Project	IEEE 802.16 Broadband Wireless Access Working Group < http://ieee802.org/16 >	
Title	16m Base Station and Relay Station Frame Structure	
Date Submitted	2008-11-01	
Source(s)	Kanchei (Ken) Loa, Yi-Hsueh Tsai, Chun-Yen Hsu, Youn-Tai Lee, Chih-Wei Su, Yi-Ting Lin, Tsung-Yu Tsai, Chiu-Wen Chen, Jiun-Je Jian Institute for Information Industry (III) Yung-Ting Lee, Hua-Chiang Yin Coiler Shiann-Tsong Sheu National Central University (NCU)	Voice: +886-2-66000100 Fax: +886-2-66061007 loa@iii.org.tw , lucas@iii.org.tw
Re:	IEEE 802.16m-08/042 "Call for Contributions on Project 802.16m Draft Amendment Content"	
Abstract	16m base station and relay station frame structure	
Purpose	We propose 16m base station and relay station frame structure	
Notice	<i>This document does not represent the agreed views of the IEEE 802.16 Working Group or any of its subgroups. It represents only the views of the participants listed in the "Source(s)" field above. It is offered as a basis for discussion. It is not binding on the contributor(s), who reserve(s) the right to add, amend or withdraw material contained herein.</i>

16m Base Station and Relay Station Frame Structure

Figure 308a Basic frame structure

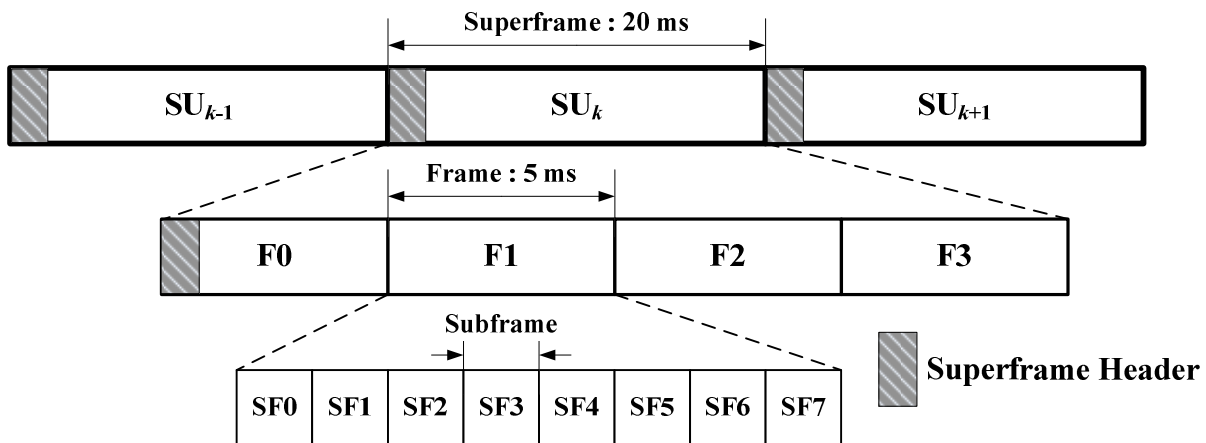
The basic frame structure, illustrated in Figure 308a, shall be applied to FDD and TDD duplexing schemes, including H-FDD MS operation. Each 20 ms superframe shall be divided into four 5 ms frames. Each frame shall consist of eight subframes when using the OFDMA parameters defined in Table xxx with the channel bandwidth of 5 MHz, 10 MHz, or 20 MHz. Each subframe shall be assigned for either DL or UL transmission.

Figure 308b BS Frame structure in TDD mode (CP of $1/8$ useful OFDM symbol time and DL to UL ratio of 5:3)

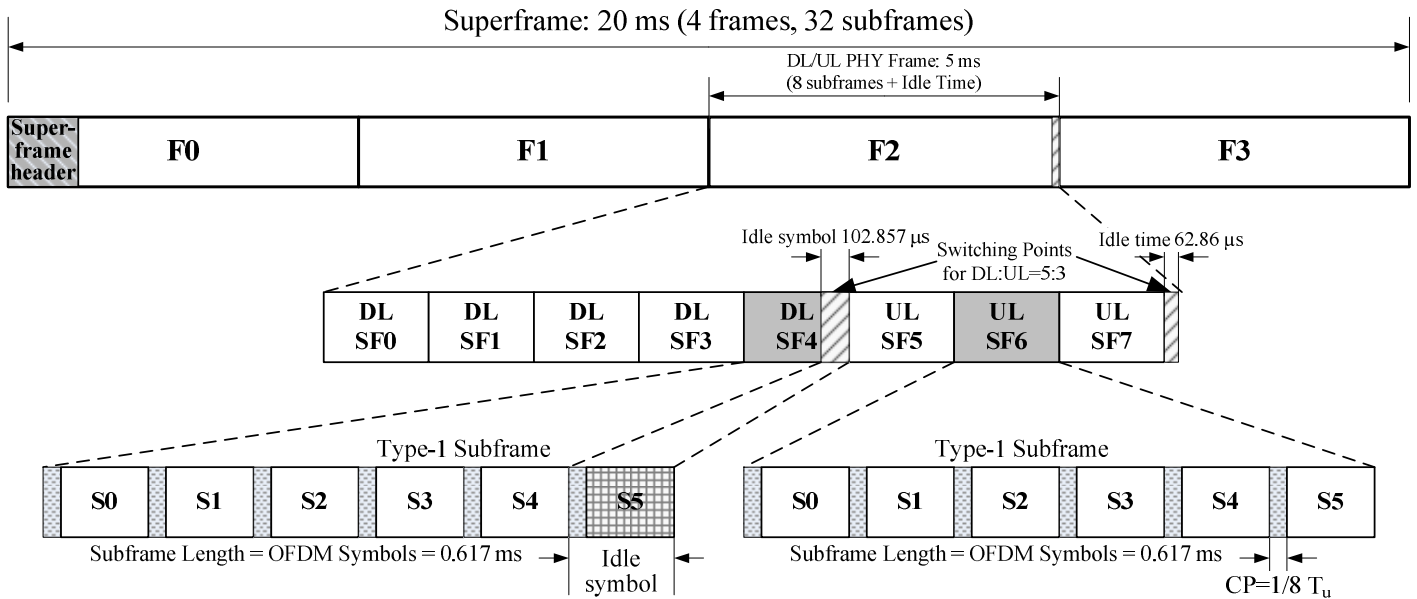
In TDD systems, the number of switching points in each radio frame is either two or four. Figure 308b illustrates an example of BS frame structure with a DL to UL ratio of 5:3, where OFDM symbol duration is $102.857\mu\text{s}$, CP length is $1/8$ useful OFDM symbol time, and the length of type-1 subframe is 0.617 ms . The last DL subframe, i.e., DL SF4, is a type-1 subframe whose last OFDM symbol is an idle symbol to accommodate the gap required to switch from DL to UL. Figure 308c illustrates an example of BS frame structure with a DL to UL ratio of 5:3, where OFDM symbol duration is $97.143\mu\text{s}$, CP length is $1/16$ useful OFDM symbol time, and the lengths of type-1 and type-2 subframes are 0.583 ms and 0.680 ms respectively.

Figure 308d TTR RS Frame Structure in TTR TDD mode (CP of 1/8 useful OFDM symbol time and DL to UL ratio of 3)

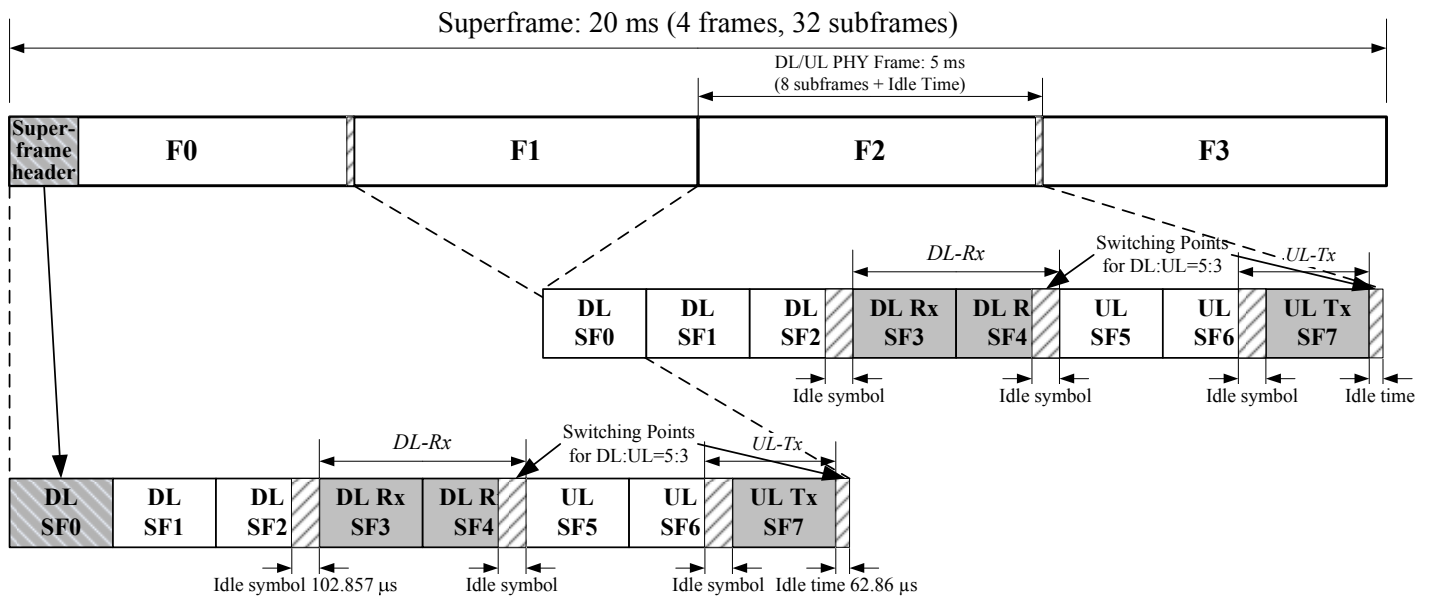
For the 2-hop relay system, the TTR RS frame may include a DL transmit zone, or a DL receive zone, or a UL receive zones, or a UL transmit zone. The BS shall not schedule any traffic for the RS except the uplink-only RS in the first DL subframe of the first frame of the superframe since it contains broadcasting management messages, such as superframe header.

Two examples of TTR RS frame structure for 2-hop relay system with DL to UL ratio of 5:3 is illustrated in Figure 308d and Figure 308e, where OFDM symbol durations are 102.857µs and 97.143 µs respectively, and CP lengths are 1/8 useful OFDM symbol time and 1/16 useful OFDM symbol time respectively.

Figure 308f BS frame structure in FDD mode (CP of 1/8 useful OFDM symbol time)

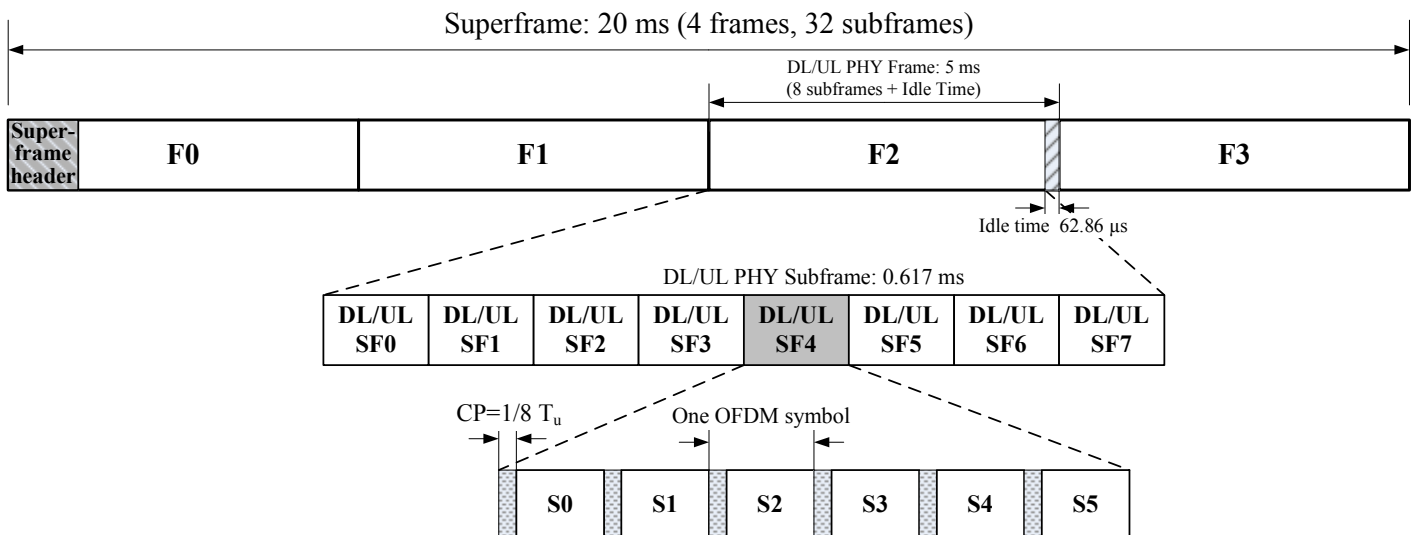
In an FDD system, when H-FDD mobile stations are included, the frame structure from the point of view of the H-FDD mobile station is similar to the TDD frame structure; however, the DL and UL transmissions occur in two separate frequency bands. The transmission gaps between DL and UL (and vice versa) are required to allow switching the TX and RX circuitry. Figure 308f shows an example of BS frame structure, where OFDM symbol duration is 102.857 μ s, CP length is 1/8 useful OFDM symbol time, and the length of type-1 subframe is 0.617 ms. Figure 308g illustrates an example of BS frame structure, where OFDM symbol duration is 97.143 μ s, CP length is 1/16 useful OFDM symbol time, and the lengths of type-1 and type-2 subframes are 0.583 ms and 0.680 ms respectively.

Figure 308h TTR RS Frame Structure in FDD mode

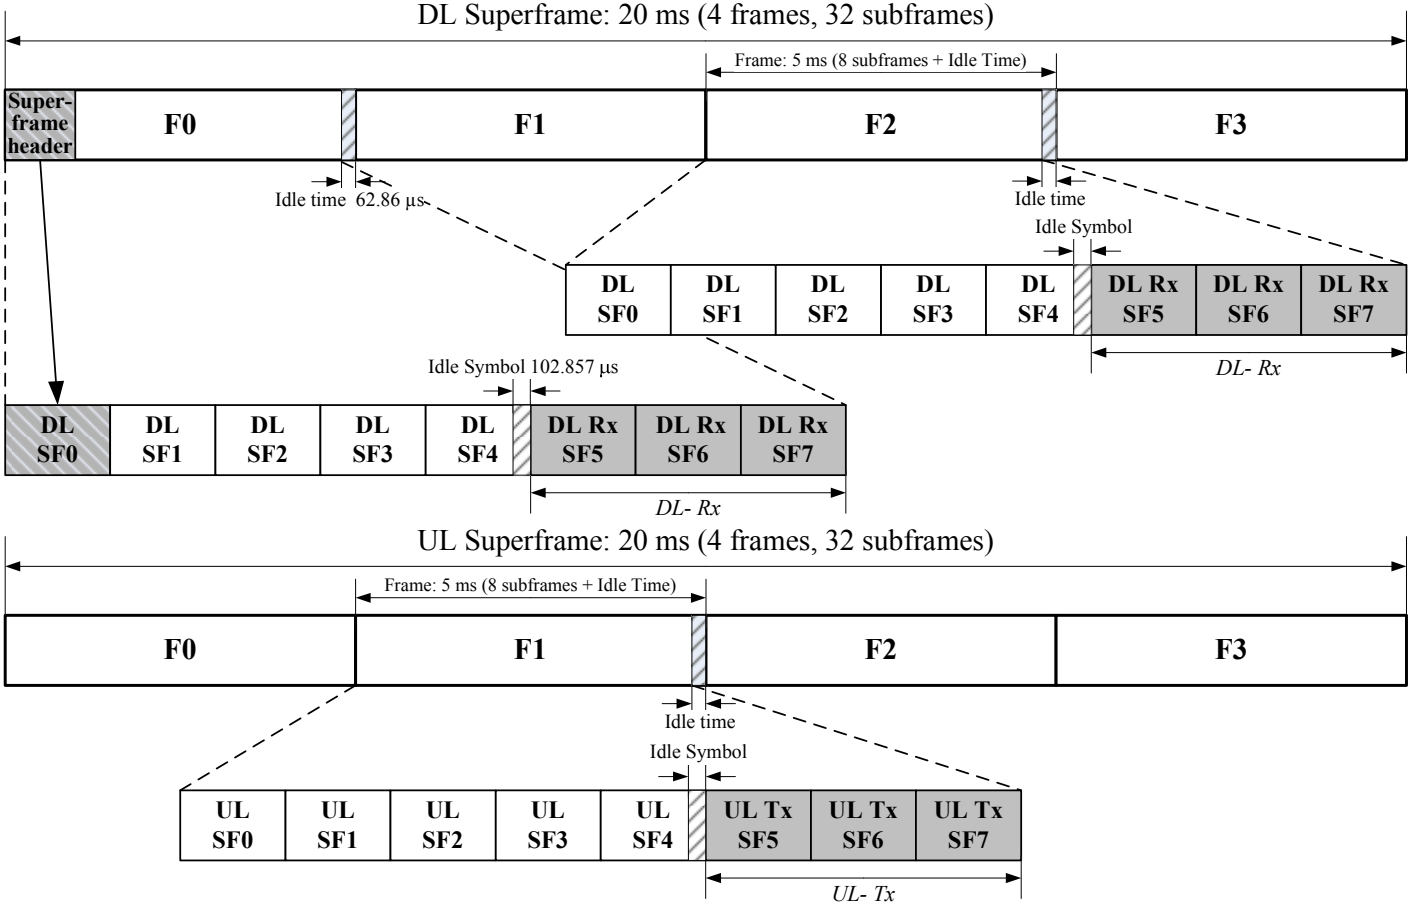
For the 2-hop relay system, the TTR RS DL frame may include a DL transmit zone, or a DL receive zone, and the TTR RS UL frame may include a UL receive zones, or a UL transmit zone. The BS shall not schedule any traffic for the RS except the uplink-only RS in the first DL subframe of the first frame of the superframe since it contains broadcasting management messages, such as superframe header.

A examples of TTR RS frame structure for 2-hop relay system with DL to UL ratio of 5:3 is illustrated in Figure 308h.
